# 1961 Corvette: Service Bulletin: Corvette Grille Vibration

**Subject:** Corvette Grille Vibration

**Bulletin No:** Page 1, Section XIII, Group 2

**Date:** February 2, 1961

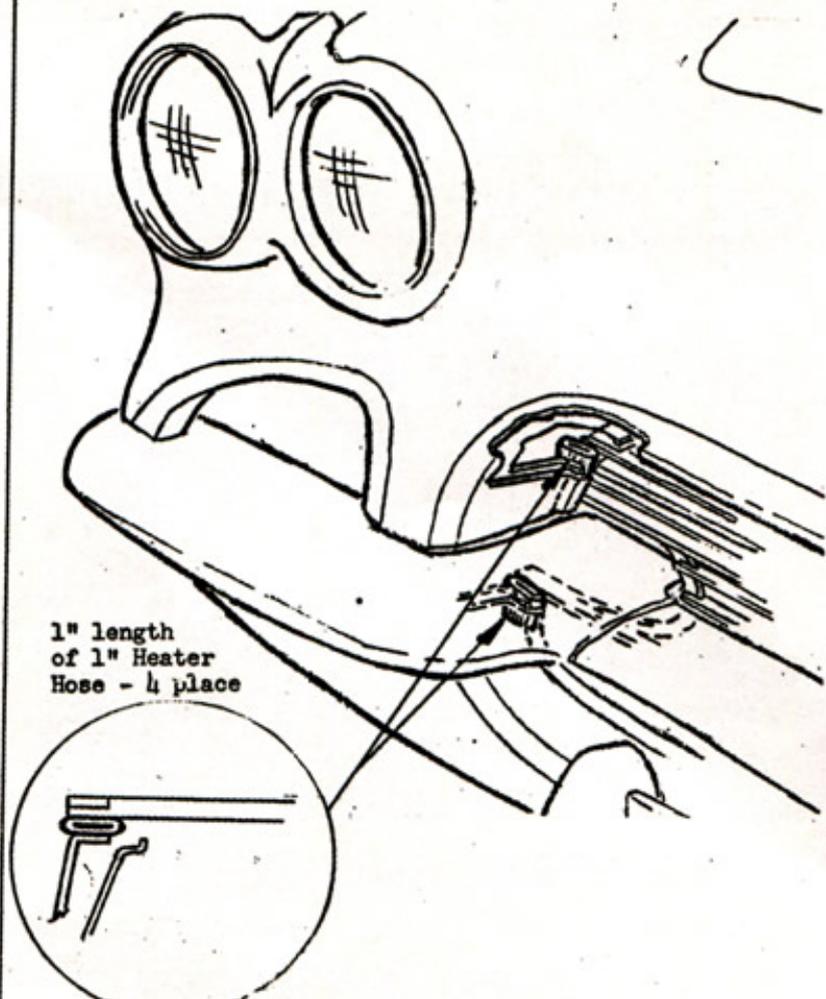
A shrill whistling noise on early production Corvette Models at speeds of 40-60 MPH may be caused by grille vibration. The condition can be minimized by wedging four (4) one inch long pieces of one inch I.D. heater hose between the grille and front end sheet metal as illustrated.
